Reliability Analysis Update

Transmission Expansion Advisory
Committee

April 11, 2019

DAYTON/AEP Transmission Zone

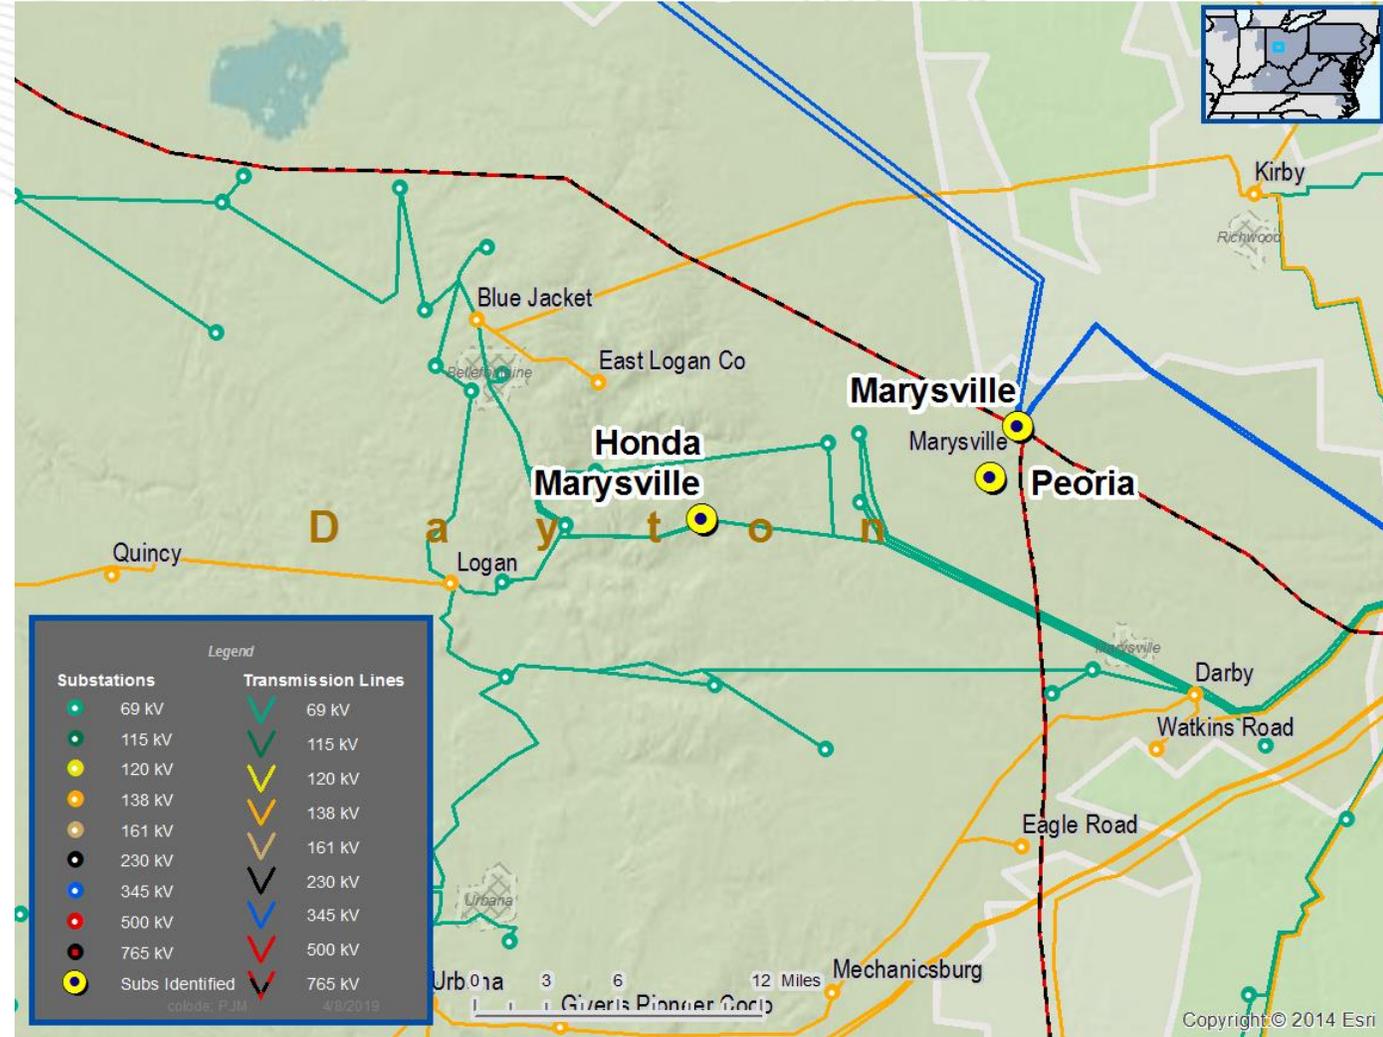
Cost updates and New Sub ID needed for AEP portion of work for B1570, previously presented on 5/12/2011, 9/8/2011 TEAC

New Project Description:

- B1570: Add a 345/69kV transformer at Dayton's Peoria 345kV bus
- B1570.1: Add/Reconductor Peoria 69kV – Darby 69kV
- B1570.2: Add/Reconductor Peoria 69kV – Union REA 69kV
- B1570.3: Reconductor Union REA 69kV – Honda MT 69kV

B1570.4: Add a 345kV breaker at Marysville 345kV station and a 0.1 mile 345kV line extension from Marysville to the new 345/69kV Dayton transformer Estimated Cost: **\$4.1M**

Updated cost for B1570, B1570.1, B1570.2 and B1570.3 is **\$16M**

Updated Total Project Cost: \$20.1M

Cost increase for B2833, previously presented on 1/12/2017 TEAC

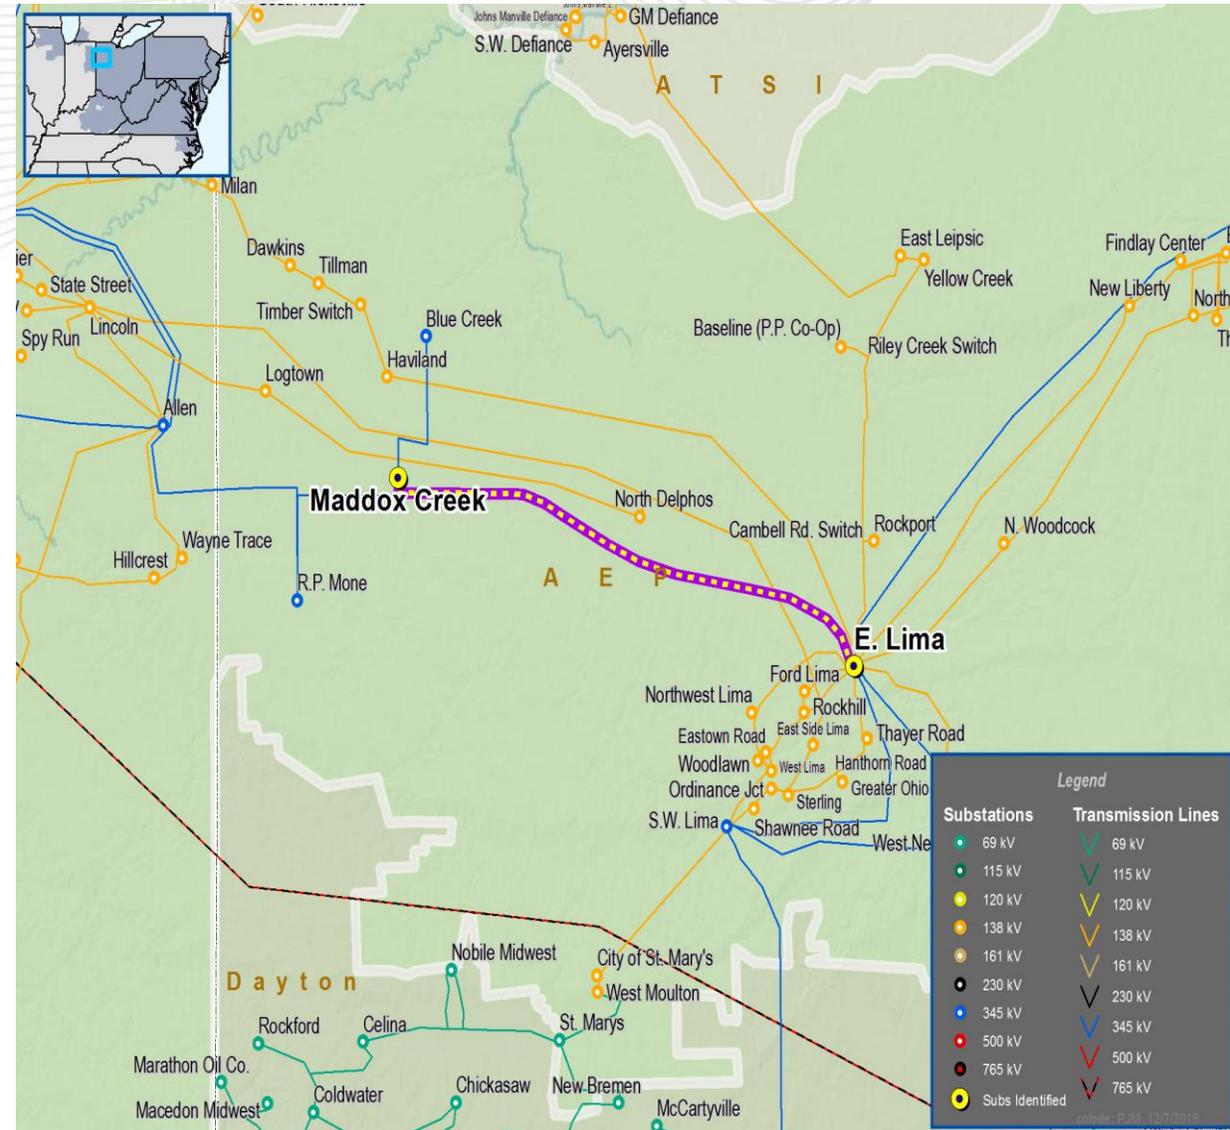
- B2833: Reconductor the Maddox Creek to East Lima 345 kV circuit with 2-954 ACSS Cardinal conductor. (2016_3-4D)
- **Driver:**
 - Winter Generator Deliverability (FG# 123) in 2016 proposal window 3: Maddox Creek to East Lima 345 kV circuit is overloaded for single contingency loss of the Marysville – Sorenson 765 kV circuit.

- **Alternatives considered:**
 - 2016_3-3A (\$ 5.95 M)
 - 2016_3-4D (\$ 18.2 M)
 - 2016_3-4F (\$ 67.7 M)
 - 2016_3-4G (\$ 69.3 M)
 - 2016_3-7A (\$ 55.9 M)
- **Original Estimated Cost: \$18.2M**

- **New Estimated Cost : \$ 30.5M**
- **Reason for the Cost Increase:**
 - Access cost increased \$6M. Detailed project development and access plan review showed a much higher cost would be expected if traditional access roads were used to perform construction. Helicopter construction will be used as the more cost-effective approach to reduce need for mitigation of access roads and impact to property owners.

- Labor and material cost for tower and hardware assemblies were updated, resulting in a \$6.3M increase.
- **Required IS Date: 12/1/2021**

Dominion Transmission Zone: Baseline 230kV Line #2063 and Partial 230kV Line #2164 Rebuild

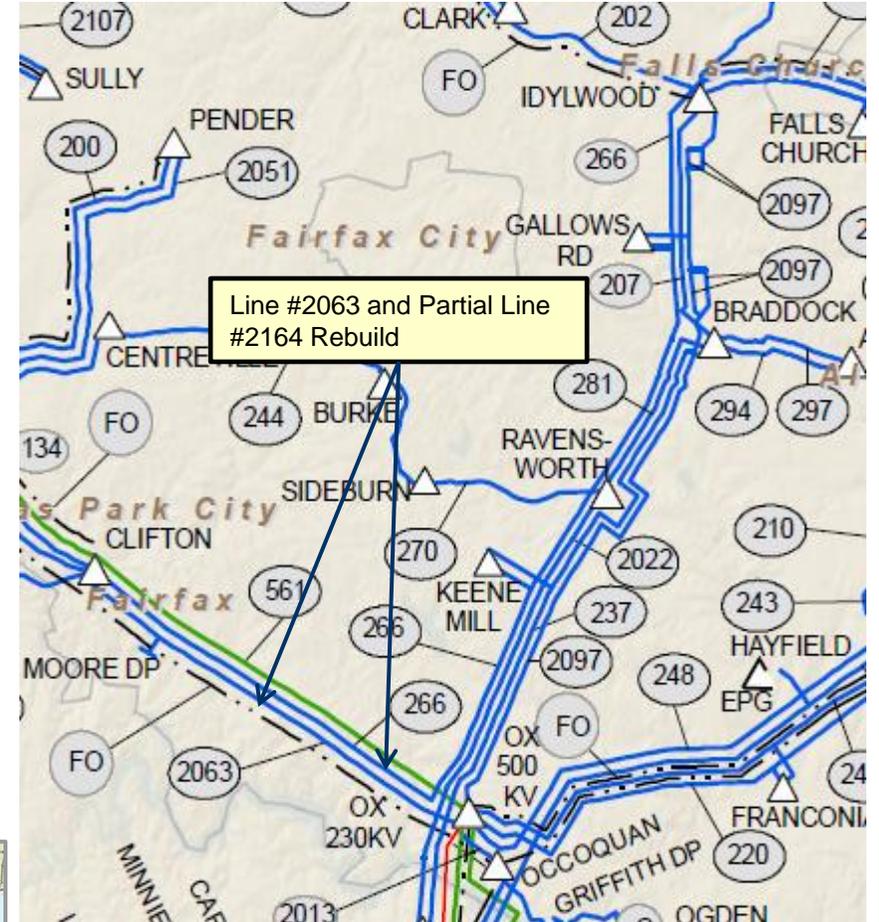
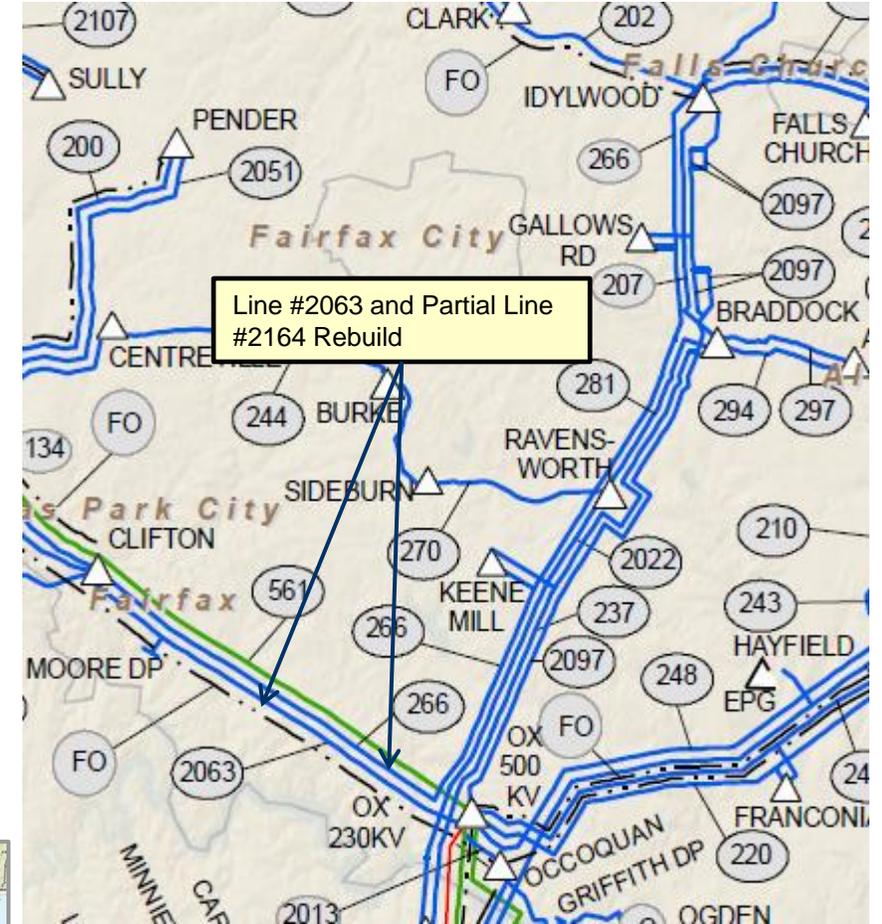
Problem Statement: Dominion “End of Life Criteria”

The 230kV Line #2063 from Clifton to Ox is roughly 7.16 miles long and was constructed on Cor-ten lattice-type double circuit towers in the 1960s. A roughly 7.1 mile long section of 230kV Line #2164 (currently Line #266) between Clifton and Keene Mill is on the same structures as Line #2063. These towers have been shown to have inherent corrosion problems that continuously deteriorate the steel members. These lines have been identified to be rebuilt as part of Dominion’s End of Life criteria.

Line #2164 is part of the network feed to Idylwood Substation supplying over 100 MW of load that is required to meet Dominion’s Transmission Planning Criteria. It has tapped load at Keene Mill Substation and Gallows Road Substation totaling 118 MW.

Line #2063 is the only source for the tapped load at Moore D.P.

Rebuild 230kV Line #2063 and Partial 230kV Line #2164 with double circuit steel structures using double circuit conductor at current 230kV northern Virginia standards with a minimum rating of 1200 MVA. **(b3096)**

Estimated Project Cost: \$22.0 M

Project Cancellation

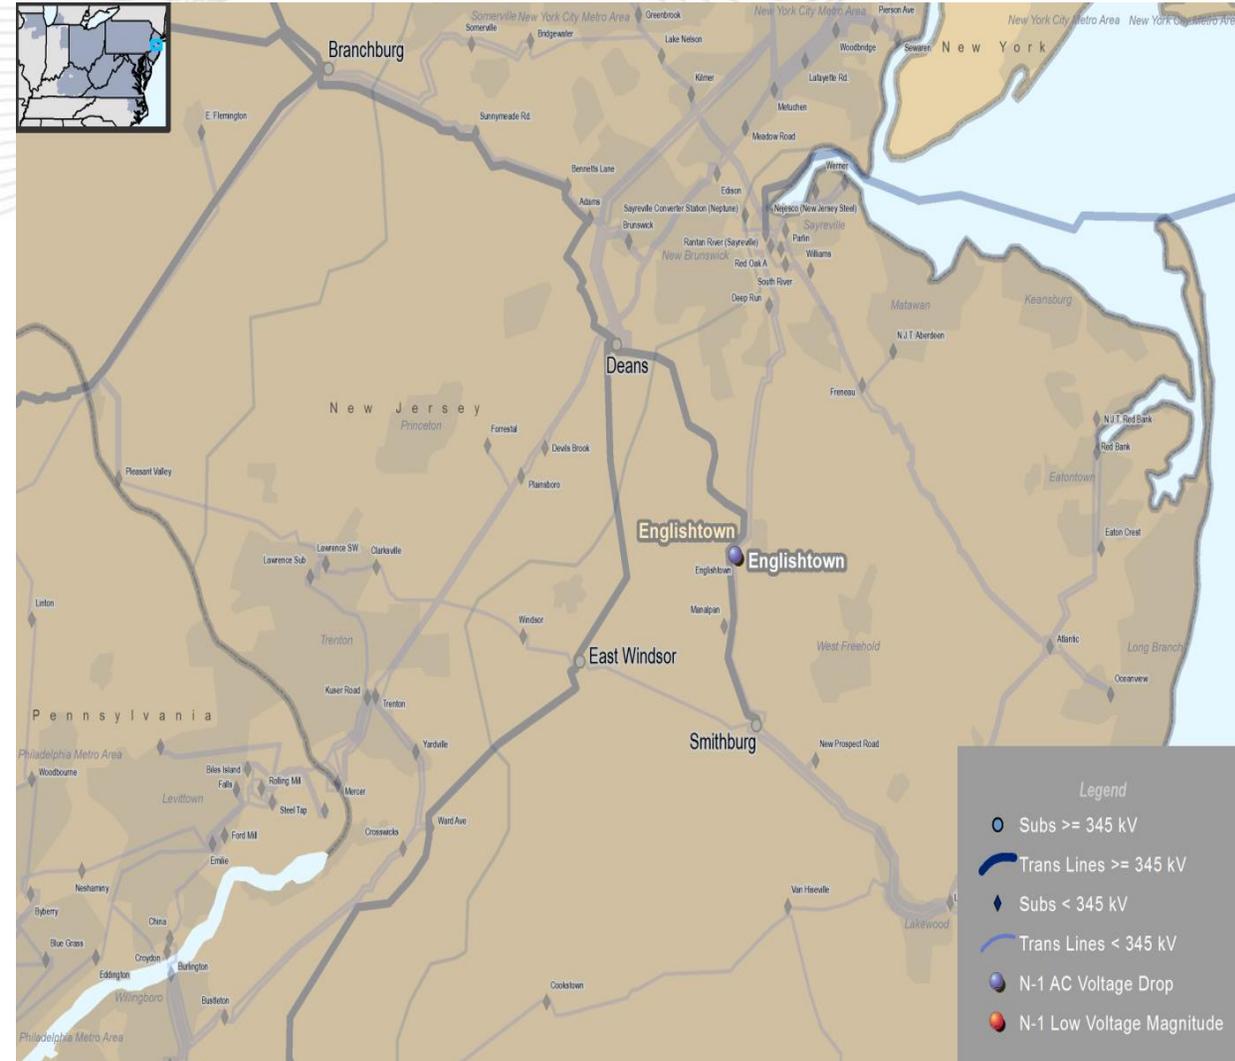
- Cancellation of the B2676 project:
- The B2676 (Install one 72 MVAR fast switched capacitor at Englishtown 230 kV) was identified to mitigate voltage violation at Englishtown substation for N-1-1 condition in 2015.
- The upgrade is no longer required due to a lower load forecast and other Englishtown area upgrades.
- PJM performed all required analysis without the Englishtown 230 kV fast switched capacitor and didn't identify any issue.
